Access Compliance Report

Public Rights-of-Way

(Curb Ramps)

Intersection ID: 5784	Main Street: FOSTER_BROOK_DR	Cross Street: OAKDALE_GREEN_DR	Location: NW
ADA ID: 1B908B66BEB8	Ramp Type: BlendTrans2	Initial Pass/Fail: Fail	Overall Compliance: No
Severity Score: 17.5			
Codes/Mitigation Info/Possible Solution		Field Measurements/Component Compliance

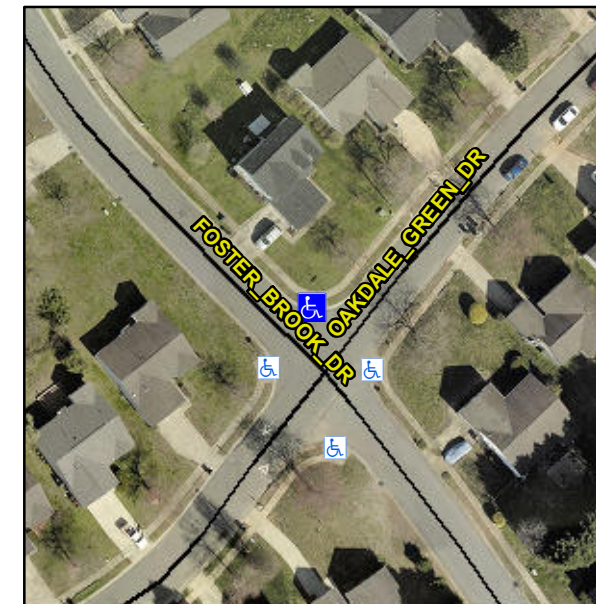
Not Found, R304.5.1

Compliance	Description	Data	Compliance	Description	Data
N/A	Ramp Length (in)	98.0	Yes	BlendTrans Slope (%)	3.2
No	Ramp Width (in)	32.0	Yes	BlendTrans XSlope (%)	1.9
N/A	Flare Type LT	N/A	N/A	Flare Type RT	N/A
N/A	Flare Slope LT (%)	N/A	N/A	Flare Slope RT (%)	N/A
N/A	Flare Traversable LT?	N/A	N/A	Flare Traversable RT?	N/A
N/A	Landing Length (in)	N/A	N/A	DWS Provided?	N/A
N/A	Landing Width (in)	N/A	N/A	DWS Contrast?	N/A
N/A	Landing Slope (%)	N/A	N/A	DWS Length (in)	N/A
N/A	Landing X Slope (%)	N/A	N/A	DWS Full Width?	N/A
N/A	Landing Curb? (Y/N)	N/A	N/A	DWS Offset (in)	N/A
N/A	Shared Landing?	N/A			
N/A	Gutter Ponding?	N/A	N/A	Gutter Slope (%)	N/A
N/A	Gutter Lip Ht (in)	1.0	N/A	Gutter X Slope (%)	N/A
N/A	Painted X Walk1?	No	N/A	Painted X Walk2?	No
	X Walk 1 Direction	To SW		X Walk 2 Direction	To SE
	X Walk 1 Width (in)	N/A		X Walk 2 Width (in)	N/A
	X Walk 1 Slope (%)	0.6		X Walk 2 Slope (%)	4.1
	X Walk 1 X Slope (%)	3.9		X Walk 2 X Slope (%)	0.5

N/A	Ramp inside XWalk1?	N/A	N/A	Ramp inside XWalk2?	N/A
	Road Slope (%)	2.2		Clear Space?	N/A
	Road X Slope (%)	4.0	N/A	Clear Space to XWalk (in)	N/A
N/A	Any Obstructions?	N/A	N/A	Storm Grate/Utility Hazard?	N/A
	Obstruction Type			Storm Grate/Utility Type	
		N/A			N/A
			Yes	Surface Condition? (G/P)	Good
			No	Curb Slope (%)	14.7

Remove & Replace Curb Ramp With Two New Directional Ramps or Equivalent.
